Office Action Summary

10/707,539

REITER, MARKUS

DETAILED ACTION

FIG. 2

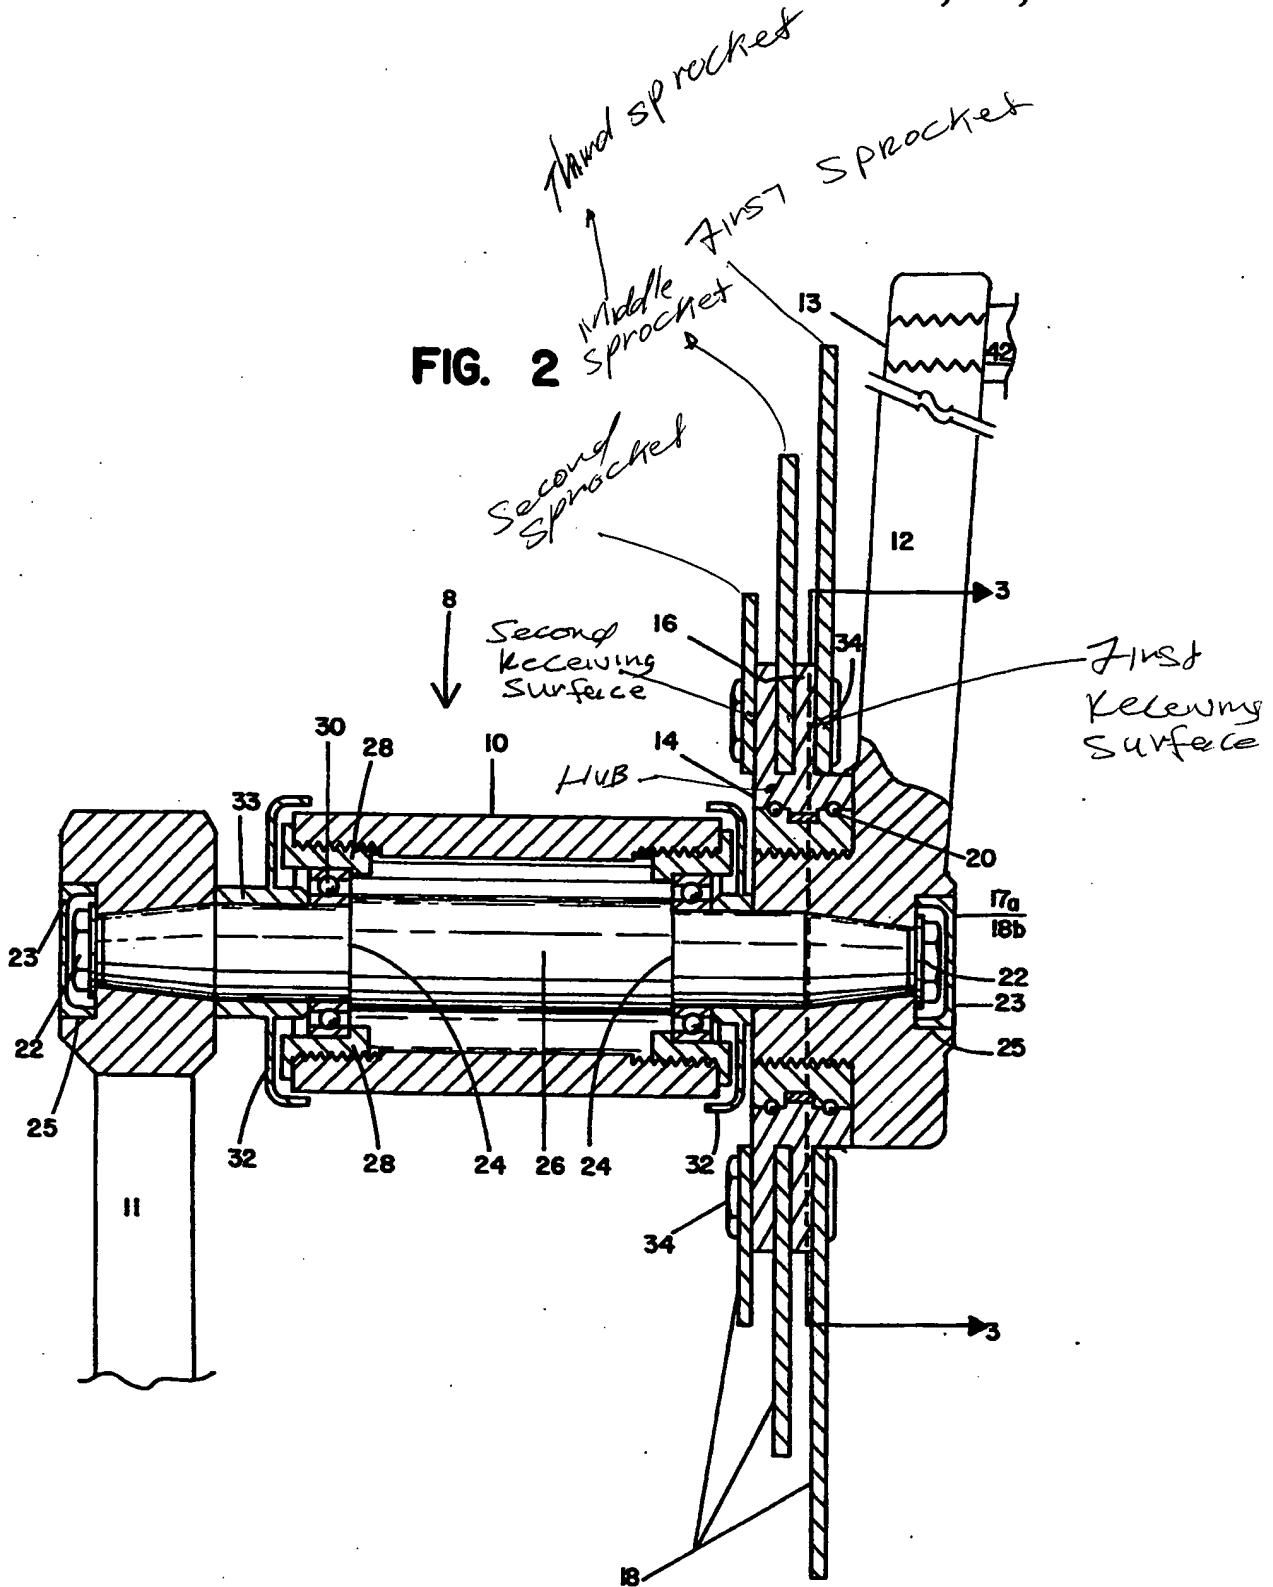
9. Claim 3 is rejected under 35 U.S.C. 103(a) as being unpatentable over Brion in view of Yang (5,782,713). Brion fails to disclose the sprocket includes a plurality of mounting tabs. Yang discloses a plurality of sprockets having a plurality of radially extending tabs (see attached illustration of fig. 1). Therefore, it would have been obvious to one of ordinary skill in the art at the time of the invention to modify the sprockets of Brion so as to include radially extending tabs as shown by Yang in order to increase the weights of the sprocket and to properly align the sprocket with the mounting holes of the hub.
